Memo

Re: Consultation on an Application

Planning Application Ref: PL/25/1706

Address: Forbury Retail Park, Kenavon Drive, Reading, RG1 3HS

May 2023 - Previous Submitted Scheme

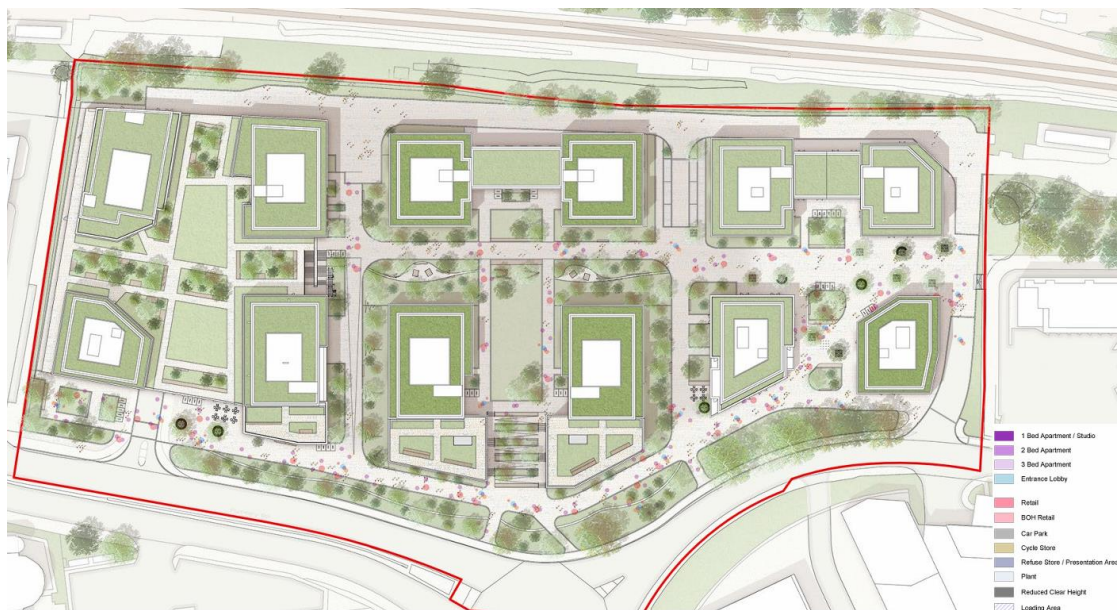
Whilst these are not labelled on the Roof Plan in 4.10.7 (P.113) of the DAS, I assume all green areas will be green roofs.

6.6.1:

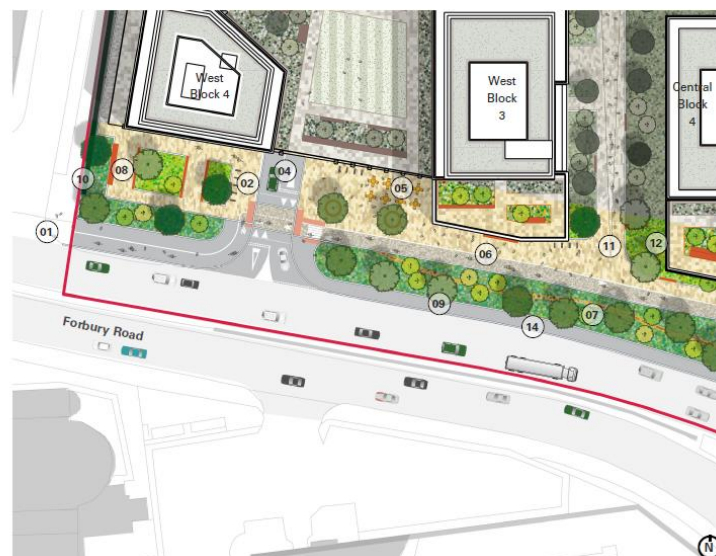
These indicate ‘large scale street trees’ (point 9) but no large canopy trees are proposed in the tree palette.

The section through relevant to the frontage of East Block 3 shows the following:

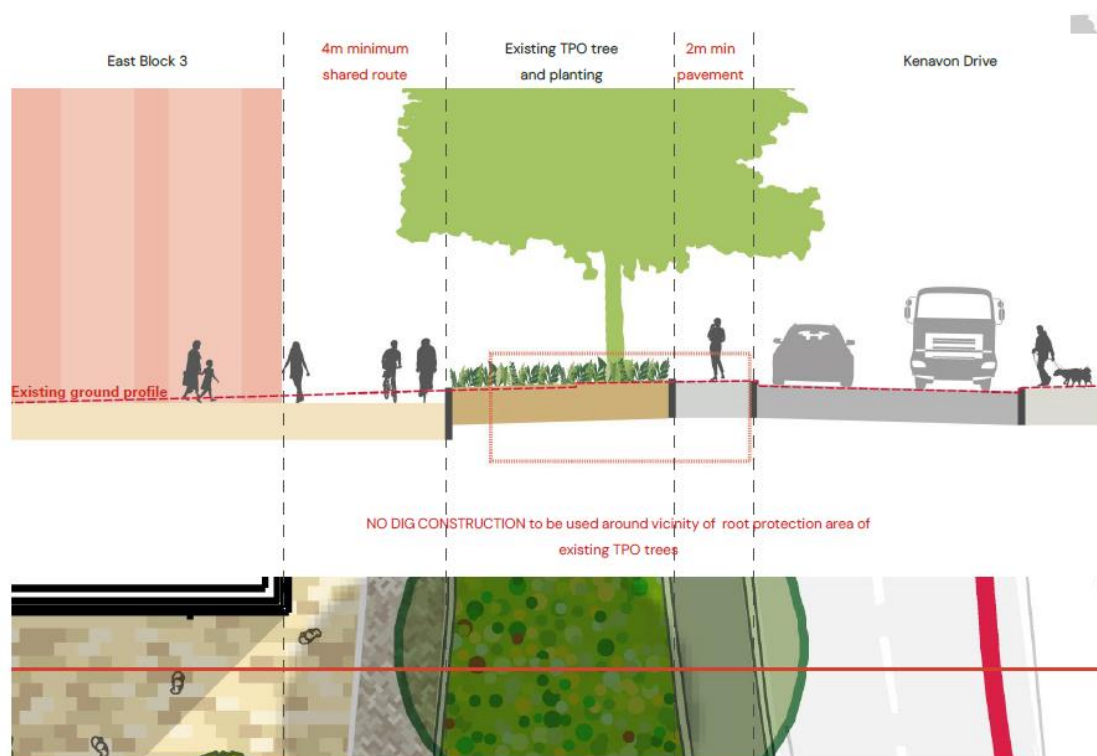
This both shows the existing ground level within RPAs to be lowered AND specifies a no-dig construction. Clarity will be expected on this prior to a decision – as I requested in 2023. The lack of AIA does not help to assist on this point. Such sections are not unhelpfully not included in the Design Codes.

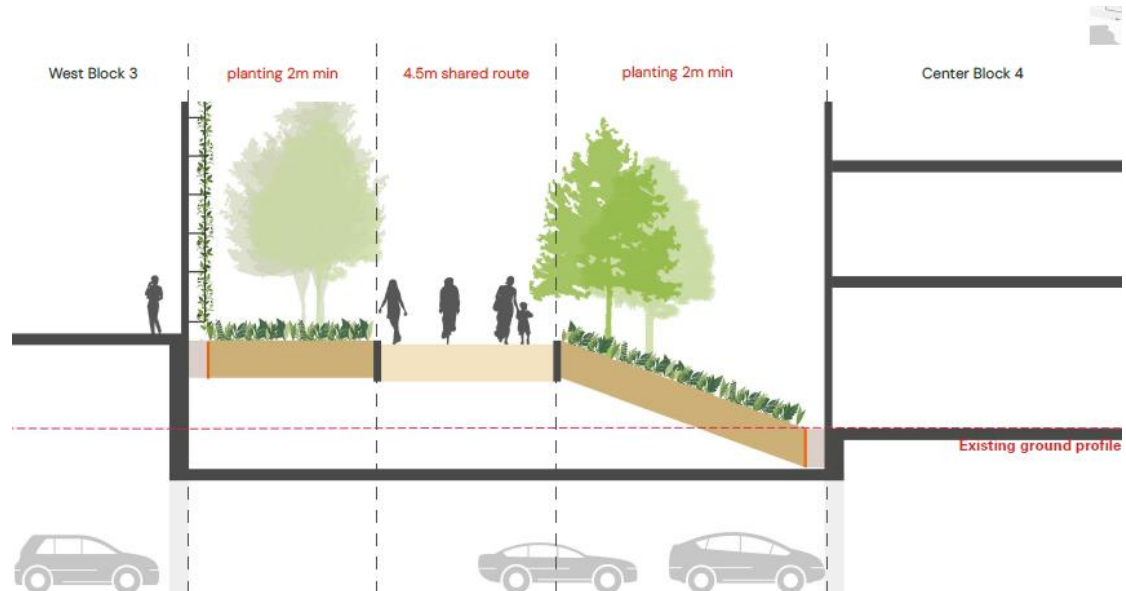
I note the gradient of the land as shown on P.210 & 211 between West Block 3 and Centre Block 4 and assume this is necessary – it is less favourable for tree establishment to be on sloped ground and this will need to be addressed in future landscaping specifications and maintenance details:

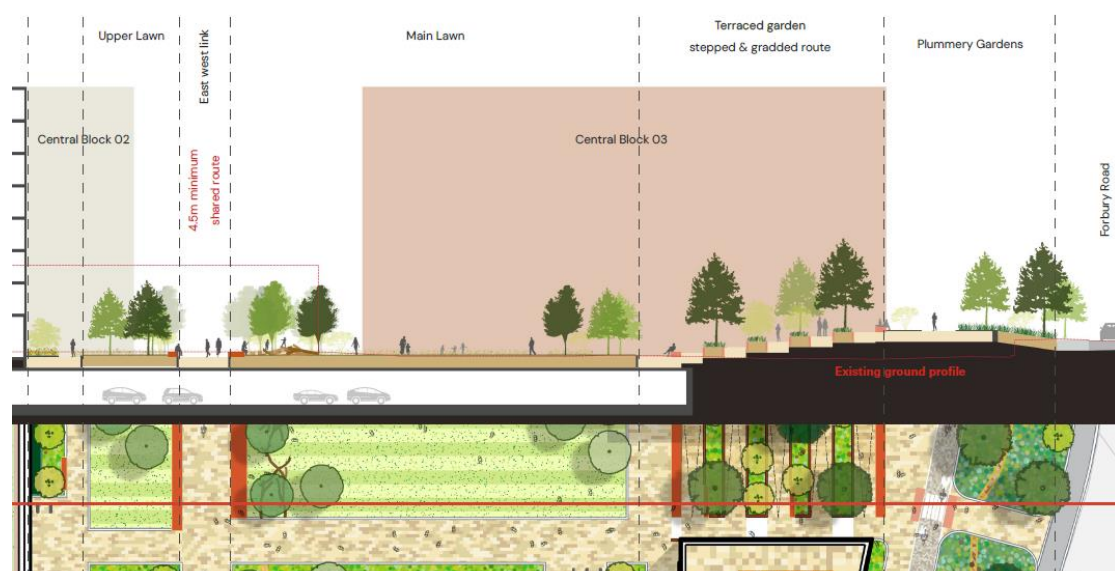
6.6.5 further demonstrates the challenges of levels across the site which demonstrates the need to consider and soil volume provision carefully to ensure every tree has a sufficient rooting volume:

On this point of soil volume, I note the steps up & ramp shown on drawing **drawing 50582-STN-HGN-SW-DR-CH-0011 P02 within Appendix C of the Transport Assessment dated November 2025** between Center Blocks 3 & 4:

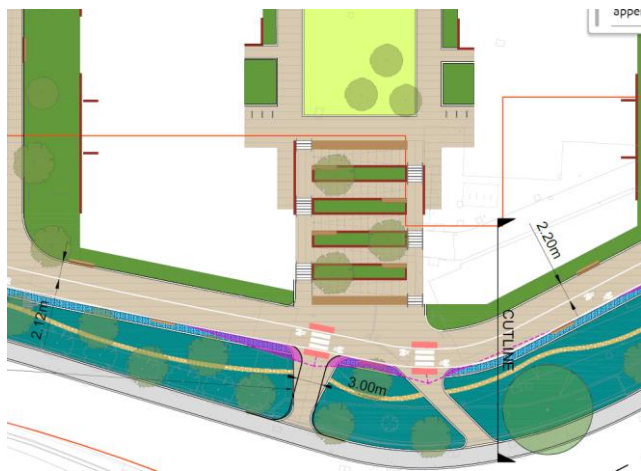
The ramp seems to provide a long, winding route to access the upper level, with tight corners which does not appear user friendly to buggies or wheelchairs. I assume comments from the accessibility officer have been sought on this. Previous comments within the Urban Design Review from Doyle Design LLP (2023 application) queried whether lifts could be considered on this site (as per Station Hill). The benefit of this would be ease of access, compared to the ramp and would then allow reconsideration of the landscaping here, along with soil volume. If it's more likely that those needing the ramp would use the more level access to the east, is the ramp superfluous?
